AMENDMENT OF SOLICITATION/MODIFICATION OF CONTRACT			1. CONTRACT ID CODE	PAGE	OF PAGES
2. AMENDMENT/MODIFICATION NO. 0002			3. EFFECTIVE DATE 4/15/2010	4 REQUISITION/PURCHASE REQ NO. N/A	PROJECT NO. (If applicable) N/A

14. DESCRIPTION OF AMENDMENT/MODIFICATION (Organized by UCF section headings, including solicitation/contract subject matter where feasible.)					
DESIGN/BUILD FACILITIES RECAPITALIZATION AND SITE CONSOLIDATION, PHASE 1, SECTOR BUFFALO, NY					
<u>AMEND SOLICITATION HSCG47-10-R-3EFK13 AS FOLLOWS:</u>					
Continued on Page 2					
15A. NAME AND TITLE OF SIGNER (Type or print)			16A. NAME AND TITLE OF CONTRACTING OFFICER (Type or print)		
15B. CONTRACTOR/OFFEROR (Same as Item 8)		15C. DATE SIGNED	16B. UNITED STATES OF AMERICA BY _____		16C. DATE SIGNED
_____ (Signature of person authorized to sign)			_____ (Signature of Contracting Officer)

FACILITIES RECAPITALIZATION
& SITE CONSOLIDATION: PHASE 1
BUFFALO NEW YORK
SECTOR BUFFALO
CIVIL
CONCEPT UTILITY PLAN

PHASE I CONCEPT UTILITY PLAN

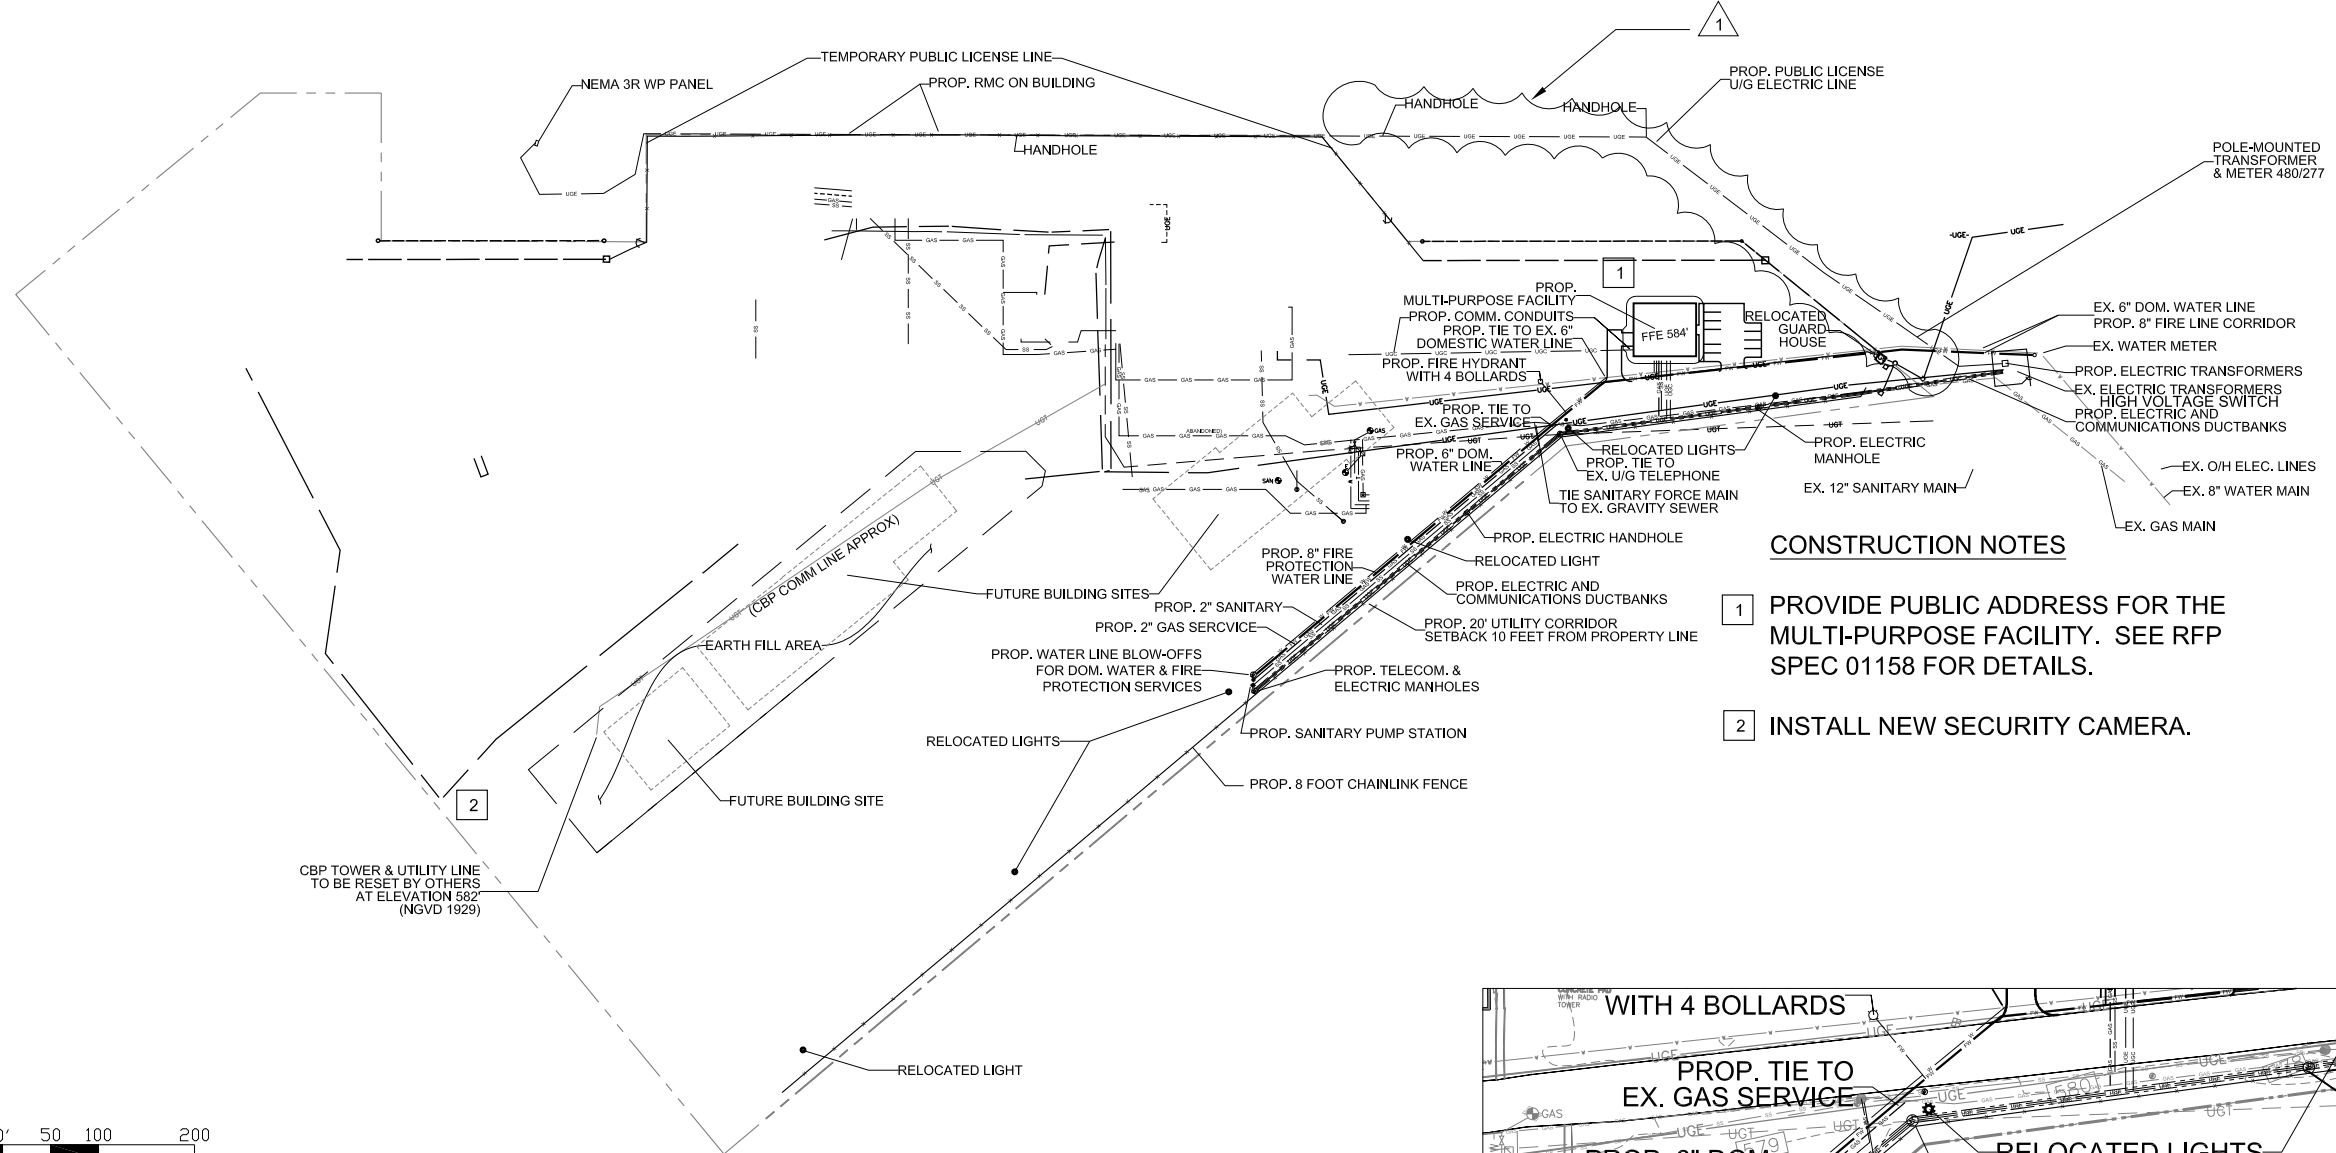
1.13.2.5.2.1 Relocate existing light poles and provide a new light pole on the south perimeter of the property as shown on the RFP drawings. New pole bases, light poles, fixtures and lamp types shall match existing. Relocate and/or provide new wiring as required to provide power for the new and relocated site lighting. Coordinate aiming of relocated fixtures to match the existing areas of coverage. Coordinate aiming of the new lighting fixture in the waterfront area with the COR to minimize impact on vessel docking operations.

ISSUE		
MARK	DATE	DESCRIPTION
△	4/12/10	NEW RIVERFRONT LIGHTING
